# PLANNING BOARD REPORT PORTLAND, MAINE

Conversion of existing school building into 8 residential units  
(Reed School Phase 2)  
19 Libby Street

Level III, Conditional Use, Subdivision and Site Plan  
Project # PLO00206-2018  
CBL: 338 Koo4001  
Reed School, LLC, Applicant

Submitted to Portland Planning Board  
Public Hearing Date: September 25<sup>th</sup>, 2018

**PREVIOUSLY APPROVED PHASE 1 SITE PLAN- ALREADY IMPLEMENTED:**

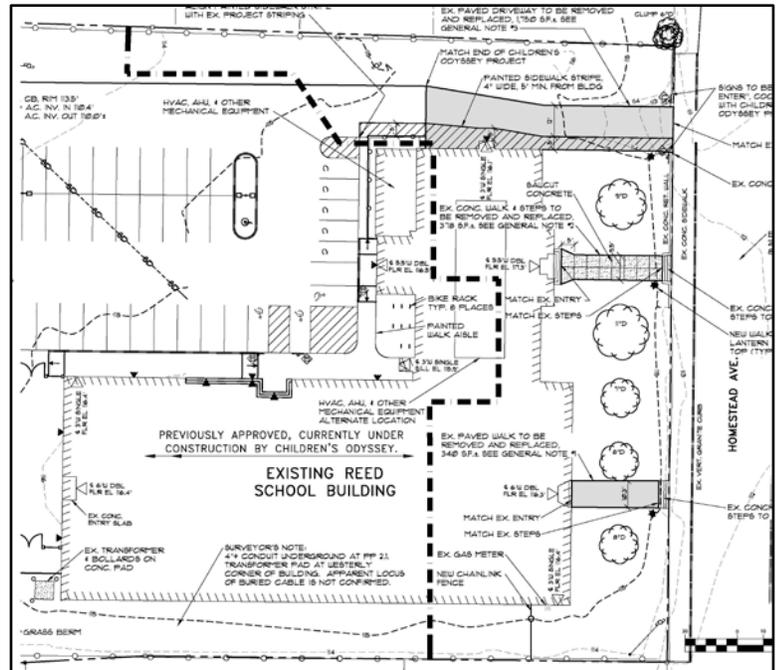
The submissions confirm that the site work was largely completed as part of the Phase 1 improvements and the current proposals do not include any landscaping or upgrade to the boundary treatment for Phase 2.
